**CERTIFICATE OF APPROPRIATENESS**

**Property:** 1807 Wroxtton Road, lot 11, block 34, Southampton Place Subdivision. The property includes a historic 2,500 square foot two-story residence with attached garage situated on a 6,600 square foot interior lot.

**Proposal:** Alteration – Construct a 460 square foot second-level addition at the rear southeast mass, and a 90 square foot second level side addition at the rear of the northwest mass. Raise flat roofs to provide clearance for insulation, systems equipment, head clearance, proper skylight installation and improved drainage. Reconstruct the damaged central corridor and replace damaged wood windows throughout with metal windows, as originally specified by the architect. Replace steel railings with glass guards at the roof deck. Replace diagonal wood siding that is causing water infiltration, with a plaster siding system.

FRONT PERSPECTIVE

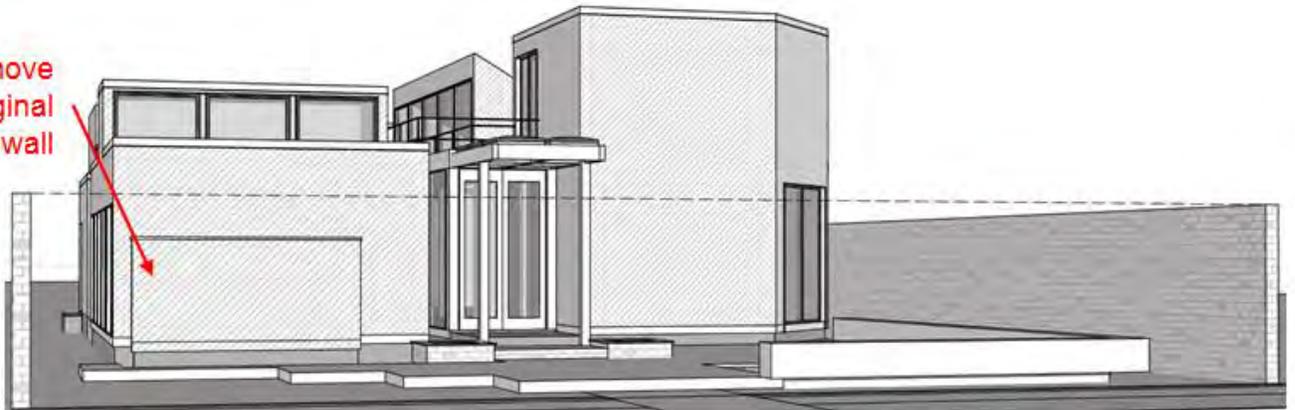
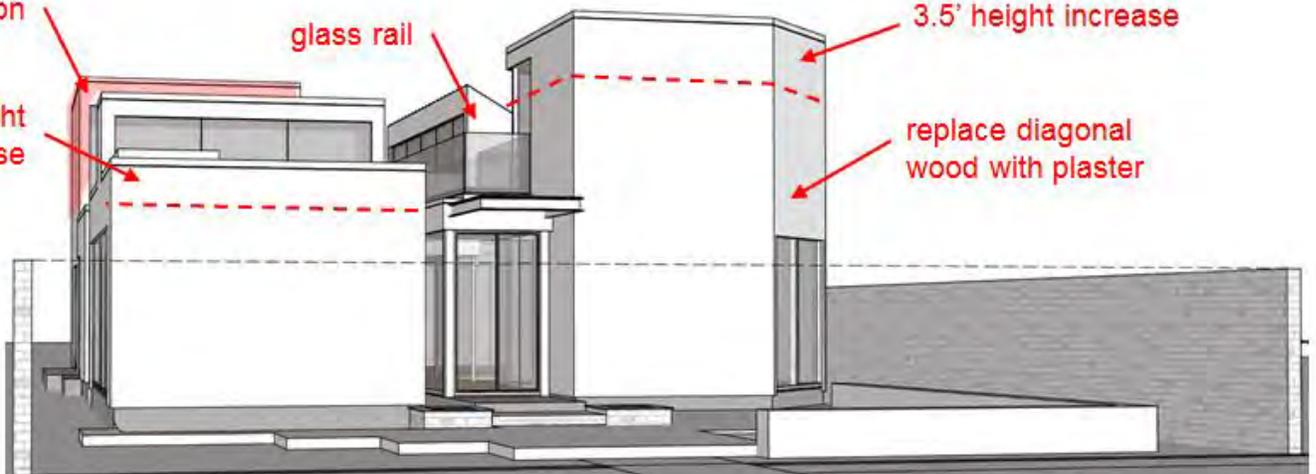
remove  
non-original  
screen wall

addition

glass rail

3.5' height increase

2' height  
increase

replace diagonal  
wood with plaster

**Denial of replacing the original diagonal wood siding with a smooth plaster surface.**

*Staff is recommending partial approval of the proposed alterations. The majority of the proposed alterations preserve the historic character of the residence by replacing failing materials with appropriate alternatives with the exception of the proposed smooth plaster exterior cladding. If diagonal wood siding is problematic, wood siding installed at the same reveal in either a horizontal or vertical orientation would be more appropriate.*
